SAFETY ALERTS

#0010

RELEASE DATE: 06/08/2019
EFFECTIVE DATE: 06/08/2019
SUBJECT: Potential risk of rudder pedal getting caught on a button head screw of the centre console when rudder is fully deflected.
MODELS AFFECTED: Sling LSA and Sling 2 aircraft fitted with rudder pedal T-pieces (Part number CT-PDL-001-L/R)
COMPLIANCE TIME: Before the next flight
LABOUR TIME: 1 hour

DIAGRAM(S):

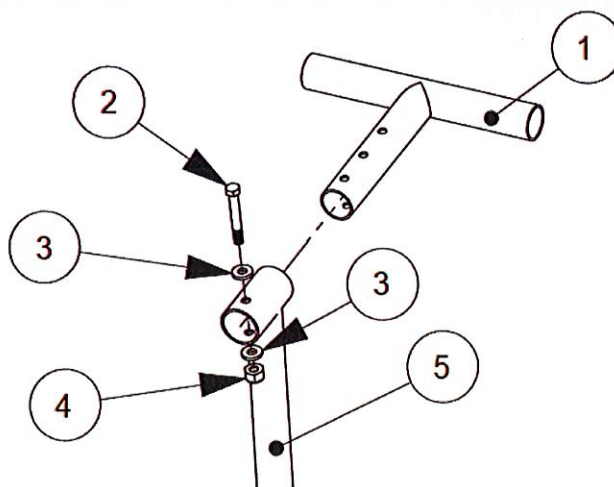
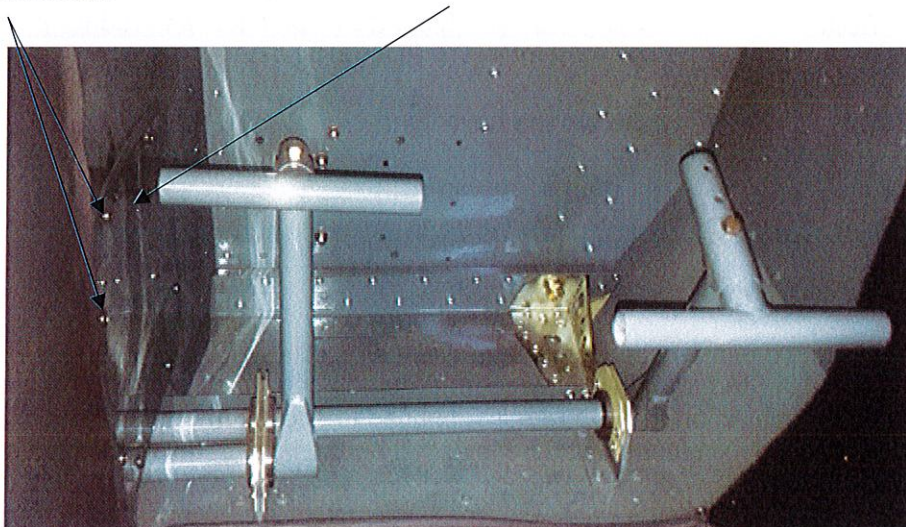
The Safety Alert provides the instructions for the rectification of rudder pedal T-pieces. This modification will prevent the rudder pedal T-piece from getting caught on a button head screw of the inspection panel cover (located on the centre console used to access the rudder stops) at full rudder deflection. The two modified T-pieces should be installed on the right pedal of the pilot side and the left pedal of the passenger side.

1. Loosen the AN3 bolt that secures the rudder pedal T-piece to the rudder pedal so that it can be removed from the airplane.

2. Measure and mark 5 mm from along each end of the rudder pedal T-piece.
3. In a vice grip or otherwise, cut and deburr the marked ends.
4. Return the rudder pedal T-piece into the rudder pedal, install the bolt and tighten with the new AN3 nyloc nuts.
5. Ensure the new clearance, after installation, between the ends of the rudder pedal T-piece and screws of the inspection panel cover exceeds 3mm.
